REGIONAL REVIEW FINDING

DATE: January 25, 2023

TO:	Chairperson Alfred John, Forsyth County
ATTN TO:	Leslie Silas, Planning Manager, Zoning Division, Forsyth County
FROM:	Mike Alexander, Director, ARC Center for Livable Communities
RE:	Development of Regional Impact (DRI) Review

Name of Proposal: 2022 North Park DRI 3782

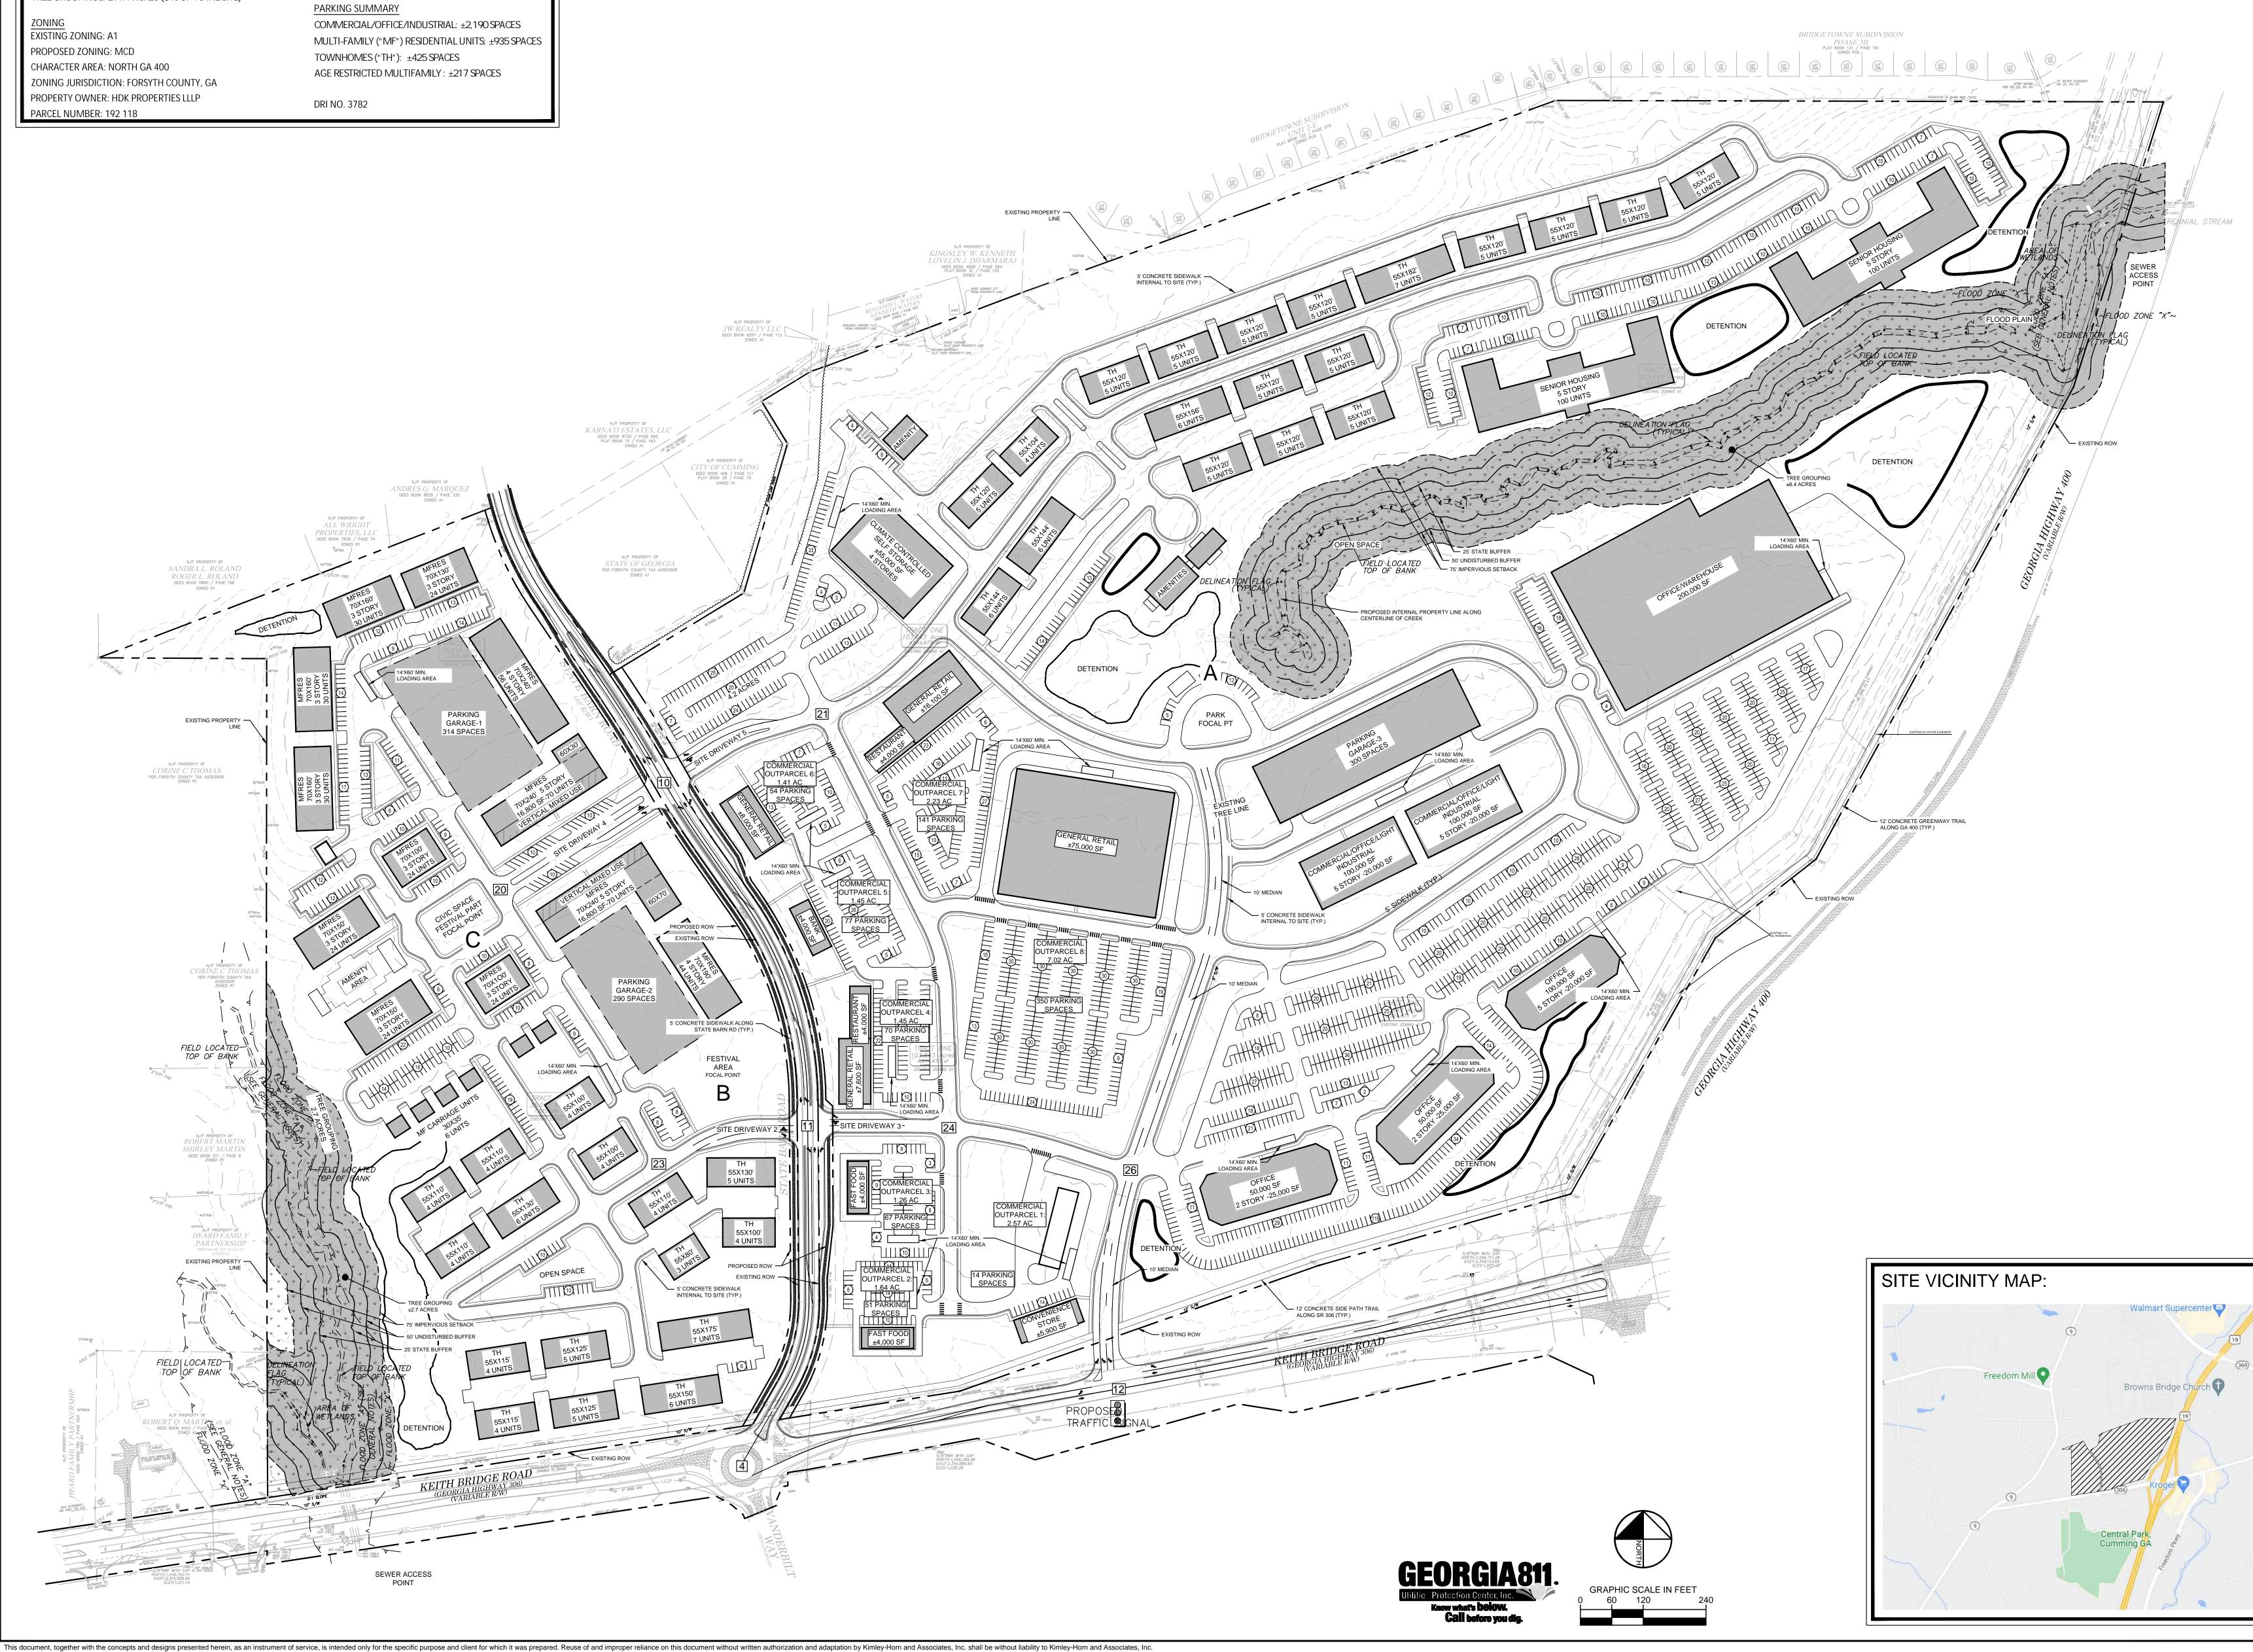
There are no crosswalks proposed in the site plan on State Barn Road to connect the two sides of the project. It will be critical to provide safe, convenient pedestrian crosswalks across State Barn Road in at least three locations – driveways 2/3, driveways 4/5, and at Keith Bridge Road – in order to meet minimal pedestrian accessibility and safety needs.

The Transportation Impact Study notes that sidewalks will be provided along the internal street network and that internal trails will be considered where possible. The site plan shows some sidewalks and crosswalks but there appear to be numerous gaps. A comprehensive internal sidewalk system and spinal internal trail system linking to a planned Forsyth County trail along Keith Bridge Road would be highly supportive of regional multi-modal transportation policies and goals.

While the mixed-use nature of the project is highly supportive of regional growth and transportation policies, most of the project's residential units are in the western section of the project which is separated from the office and retail uses in the eastern section by State Barn Road. There are no crosswalks proposed in the site plan on State Barn Road to connect the two sides of the project. It will be critical to provide safe, convenient pedestrian crosswalks across State Barn Road in at least three locations – driveways 2/3, driveways 4/5, and at Keith Bridge Road – in order to meet minimal pedestrian accessibility and safety needs.

No crosswalks are shown across Keith Bridge Road to allow access to the regional Central Park on the south side of the road. This is an essential pedestrian link that should be provided.
